DEVELOPMENT APPLICATION ASSESSMENT REPORT

Application Number:	DA2020/1383
----------------------------	-------------

Responsible Officer:	Catriona Shirley
Land to be developed (Address):	Lot 9 DP 7022, 9 Charles Street FRESHWATER NSW 2096
Proposed Development:	Alterations and additions to a dwelling house
Zoning:	Warringah LEP2011 - Land zoned R2 Low Density Residential
Development Permissible:	Yes
Existing Use Rights:	No
Consent Authority:	Northern Beaches Council
Land and Environment Court Action:	No
Owner:	Julian Michel Callebaut Diana Leigh Callebaut
Applicant:	Kyeema Claire Doyle

Figure 1: Side setbacks of the basement level.

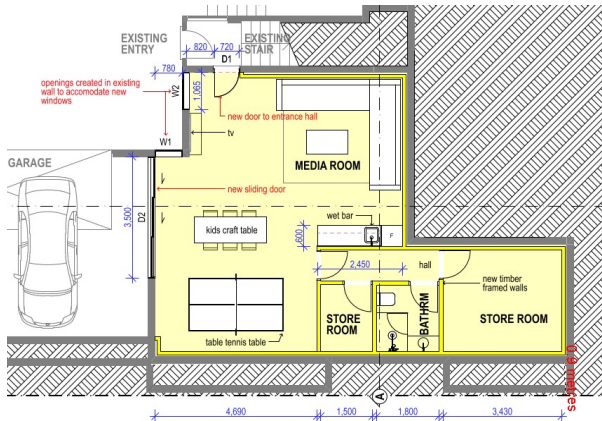
The development includes a new excavated element at the Basement level which forms a new media room and store rooms. The newly excavated area is compliant with the required side setback of 0.9m, with the existing supporting walls continuing to be located within the setback area.

The figure 1 below shows the location of the non-compliant elements within the side setback area shaded in grey.

The non-compliant element does not reduce the calculable area of deep soil landscaped area due to its dimension.

The non-compliant element is sited completely below ground and will not become visually dominant from the streetscape or neighbouring properties.

The non-compliant element is sited completely below ground, is not visually identifiable from the streetscape or neighbouring properties. As a result, the additional habitable area will not add to the scale and bulk of the building.

Whilst the new works are compliant with the requirements, a merit assessment has been undertaken to ensure consistency with the objectives of the side setback control.
